**REBUTTAL TESTIMONY**

**TIM WOOLF**

**UNION ELECTRIC COMPANY D/B/A AMEREN MISSOURI**

**Case No. EO-2011-0271**

Figure 1. Efficiency Savings as a Percent of Electricity Sales: UE versus Top 20 States<sup>2</sup>

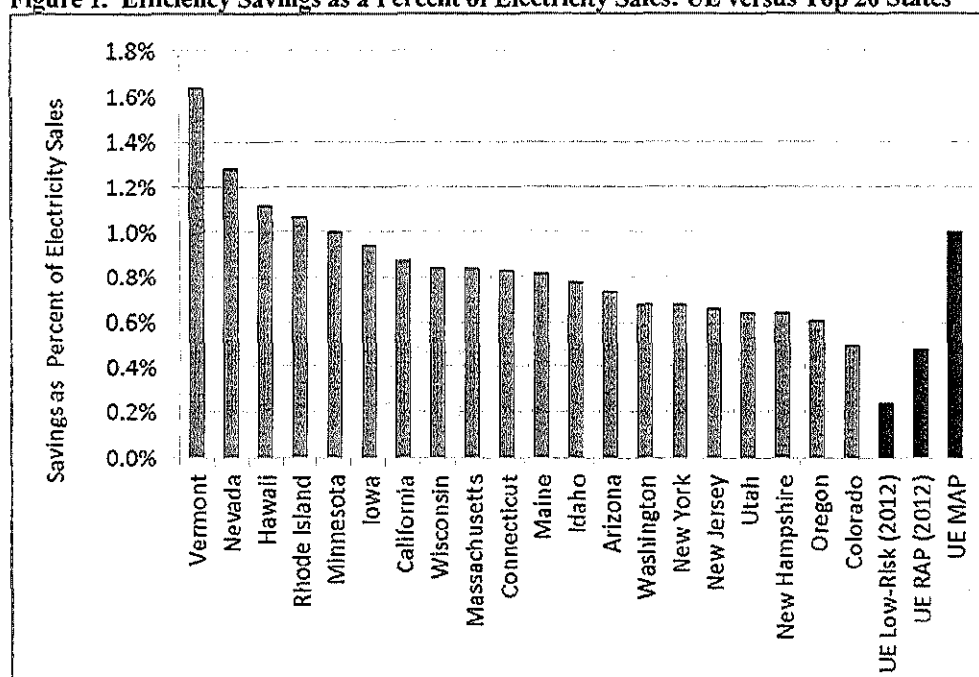
energy savings each year after 2015.<sup>1</sup> However, by 2009 five states have already achieved efficiency savings equal to roughly one percent of annual sales per year, and another 15 states have achieved efficiency savings of between 0.5 and 1.0 percent of annual energy savings per year. This is indicated in Figure 1 below. The experience of other states suggests that the MAP scenario is not the maximum that could potentially be achieved by the Company. It also suggests that there is a lot more energy efficiency that could be reasonably achieved by the Company beyond the amounts included in the RAP resource plan.

3 A. Not necessarily. I present the information on other states' efficiency activities to  
4 put the Company's planning assumptions in context. As indicated in Figure 1, the  
5 MAP scenario does not necessarily represent the upper bound of the efficiency  
6 savings that are achievable during the course of the UE IRP study period, given  
7 that many utilities have already achieved this level of savings, in 2009. Similarly,  
8 the data in Figures 1 and 2 demonstrate that in its analysis to select the Preferred  
9 Resource Plan, the Company did not assess a broad range of DSM portfolios, as it  
10 claims to have done.

**Figure 2. Efficiency Program Budgets as Percent of Revenues: UE versus Top 20 States<sup>4</sup>**

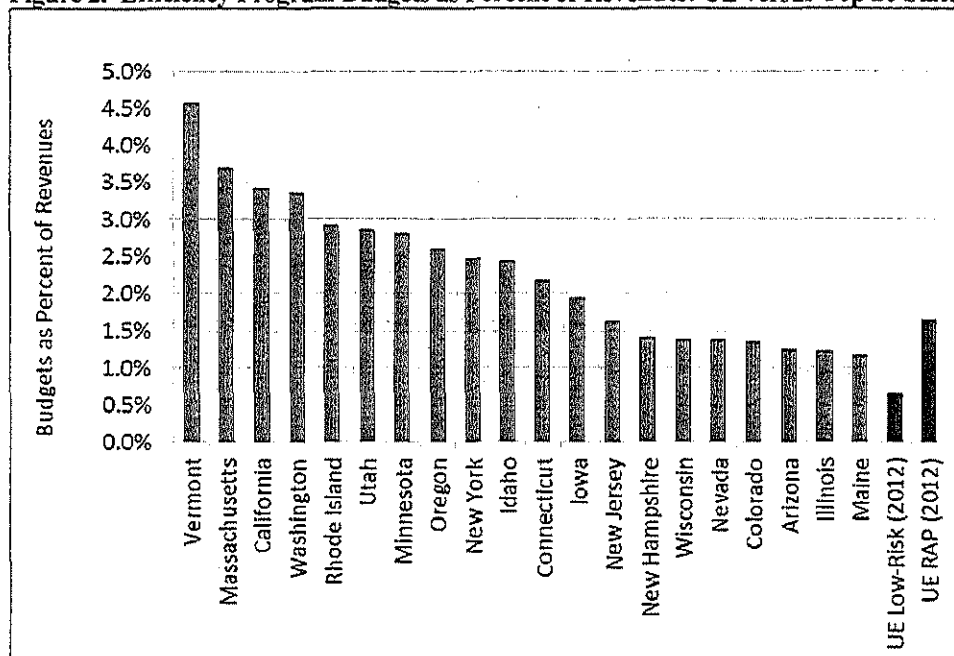
It is instructive to compare the Company's proposed Low-Risk DSM budgets to the energy efficiency budgets that are currently being implemented by other electric utilities in the US. Figure 2 presents the 2010 annual electric energy efficiency budgets for the top 20 states, as a percentage of 2010 annual electric revenues. For comparison purposes it also presents the UE 2012 budgets for the Low-Risk and RAP scenarios, also as a percent of 2010 annual electric revenues. As indicated in the figure, the Low-Risk budgets are well below many of those of other states, and the RAP budget is also well below the budgets of some states as well.

1 **Q. Are you presenting the data in figures 1 and 2 to imply that Ue should be one**  
2 **of the top states in the us with regard to energy efficiency implementation?**
